U.S. Department of the Interior BUREAU OF LAND MANAGEMENT Sundry Print Report

Well Name: PRESTON FED Well Location: T20.5S / R23E / SEC 34 County or Parish/State: EDDY /

#### **Notice of Intent**

Type of Action Plug and Abandonment

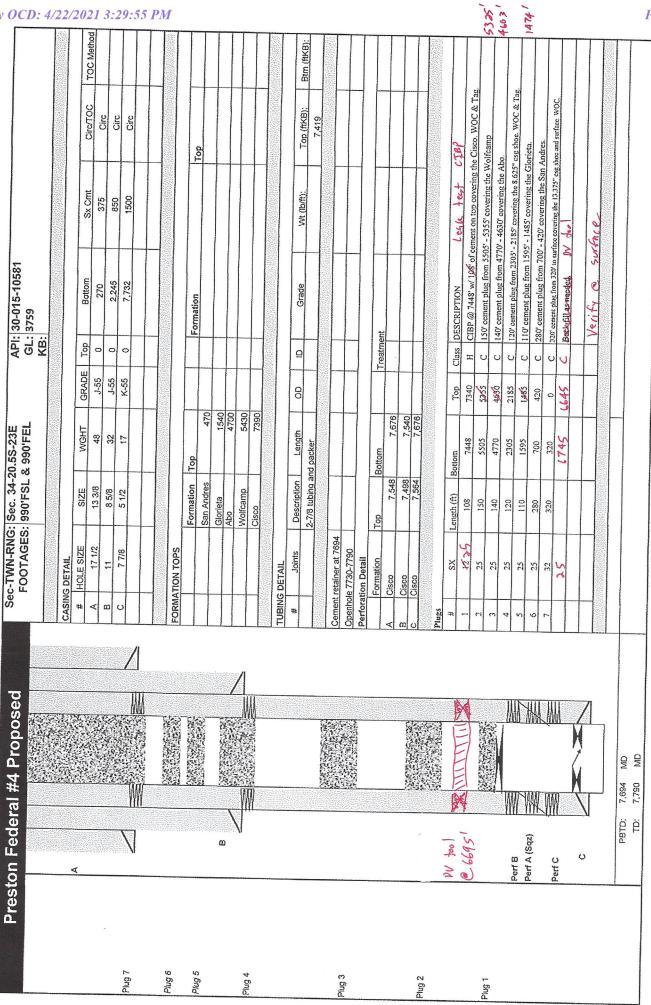
- 2. Set a CIBP at 7448 ft with 108' Class H cement on top to 7340 ft. WOC and tag. 25 5x class H Lenk test CTBP
- 3. Spot a 25 sx Class C cement plug from 5505 ft 5355 ft. This will cover Wolfcamp top. (5505' 5325')
- 4. Spot a 25 sx Class C cement plug from 4770 ft -4630 ft. This will cover Abo top. (4770'-4603')
- 5. Perforate at 2305 ft. Spot a 25 sx Class C cement plug from 2305 ft 2185 ft. This will cover 8-5/8 inch casing shoe. WOC and tag
- 6. Spot a 25 sx Class C cement plug from 1595 ft 1485 ft. This will cover Glorieta top. (1595 1474)
- 7. Spot a 25 sx Class C cement plug from 700 ft 420 ft. This will cover San Andres top.
- 8. Perforate at 320 ft. Spot a 32 sx Class C cement plug from 320 up to surface. Back fill as needed.
- 9. Cut off wellhead and install dry hole marker. Clean location as per regulated. Verity @ surface

4 Spet 25 Sx @ 6745' -6645' (DV tool @ 6695') WOC &THE 0055 C

> APPROVAL SUBJECT TO GENERAL REQUIREMENTS AND SPECIAL STIPULATIONS
